MIT NUCLEAR REACTOR LABORATORY

Subject: License Amendment Request regarding Emergency Battery Surveillances in
Technical Specification 4.6, Docket No. 50-20, License R-37

Safety Review #2020-32 -- Emergency Battery Surveillances in TS 4.6Description of Change

4.6 Emergency Electrical Power Systems

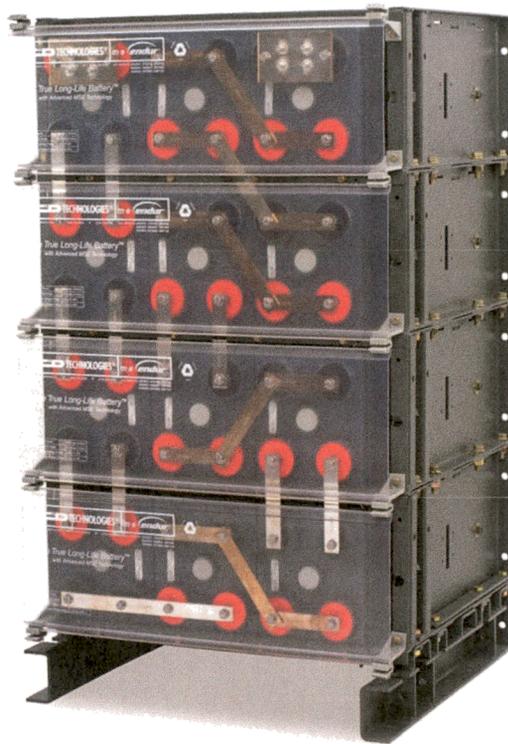
1. The ~~temperature of the negative terminal voltage and specific gravity of the pilot~~ on each battery cell shall be measured quarterly.
2. The ~~specific gravity~~ voltage of ~~all batteries~~ each battery cell shall be measured semi-annually ~~at any time that a significant change is noted in the pilot cell and at least every two years.~~
3. The connector resistance at each battery cell shall be measured annually.
4. A discharge test shall be performed once every two years.
5. Operability of the inverter motor-generator set and associated switches shall be verified annually. Performance of a discharge test satisfies this requirement.

The emergency electrical power system consists of batteries, an inverter motor-generator set, and the switches necessary to tie into the normal electrical distribution system. ~~Specific gravity and~~ Voltage measurements of individual battery cells are the accepted method of ensuring that the batteries are in satisfactory condition. In addition, periodic discharge tests are performed to detect deterioration of cells. To ensure the operability of the inverter motor-generator set, the generator and associated switches will be operationally tested.

The frequency of these component tests ~~is based on manufacturer recommendations and are based on experience to date with the MITR-II and~~ is based on manufacturer recommendations and on standard practice as recommended in ANSI/ANSI-15.1-2007. ~~Specific gravity measurements are not needed for lead-acid battery cells that use no free-flowing electrolyte. Where appropriate, the latter has been modified by the manufacturer's recommendations. Thus,~~ The discharge test frequency is biennial rather than every five years.

1. The temperature of the negative terminal on each battery cell shall be measured quarterly.
2. The voltage of each battery cell shall be measured semi-annually.
3. The connector resistance at each battery cell shall be measured annually.
4. A discharge test shall be performed once every two years.
5. Operability of the inverter motor-generator set and associated switches shall be verified annually. Performance of a discharge test satisfies this requirement.

Voltage measurements of individual battery cells are the accepted method of ensuring that the batteries are in satisfactory condition. In addition, periodic discharge tests are performed to detect deterioration of cells. To ensure the operability of the inverter motor-generator set, the generator and associated switches will be operationally tested.

The frequency of these component tests is based on manufacturer recommendations and on standard practice as recommended in ANSI/ANS-15.1-2007. Specific gravity measurements are not needed for lead-acid battery cells that use no free-flowing electrolyte. The discharge test frequency is biennial rather than every five years.
